# **Ultra 640 input offset compensation and training pattern**

**IBM Technology Group**

**July 2002**

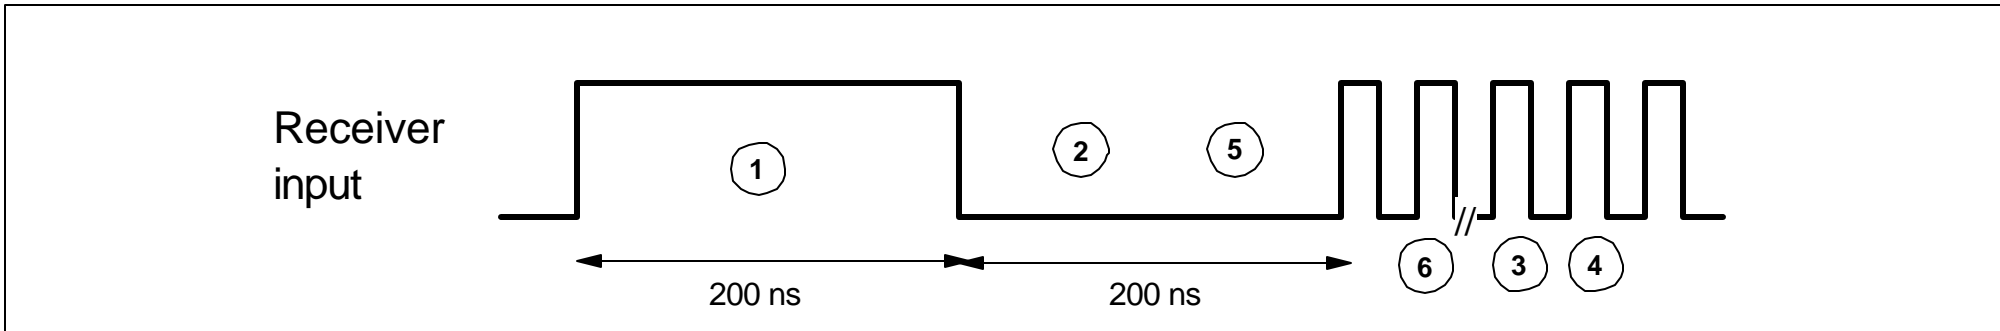
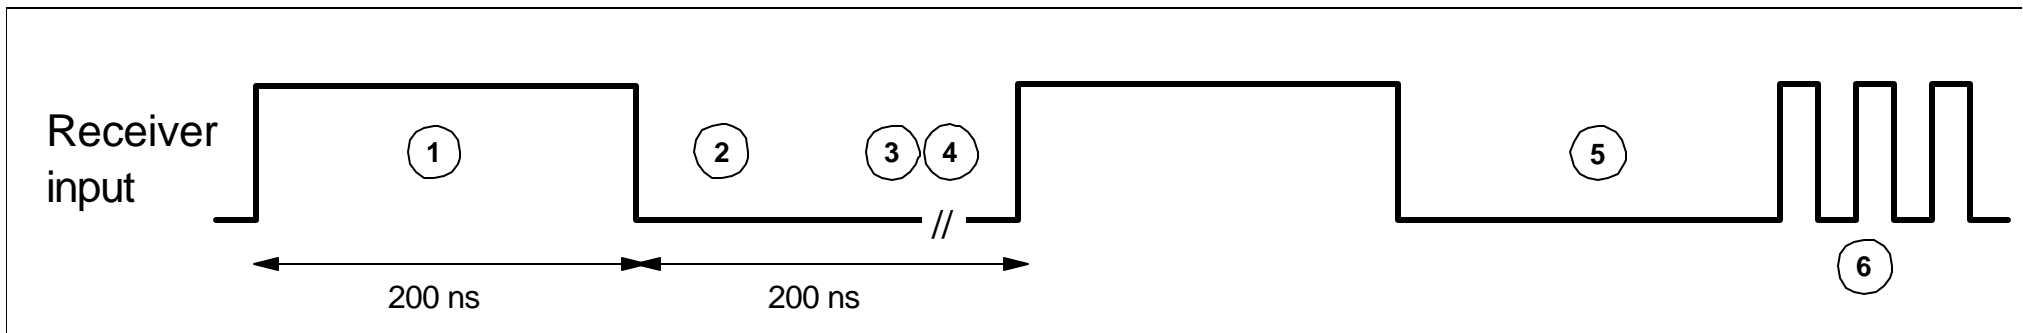
**In order to improve accuracy in the AAF adjustment phase, it is preferable to perform the DC input offset compensation BEFORE the LF and HF amplitude measurements.**

**One LF period is adequate to sample the DC input offset but is too short to allow its compensation with simple and low cost circuits before the LF and HF amplitude measurements.**

**PROPOSAL: add at least one LF period in section A to make possible the DC input offset compensation BEFORE the AAF tuning.**

\*Our proposal is to adopt the following sequence (additional LF period(s) in A section) :
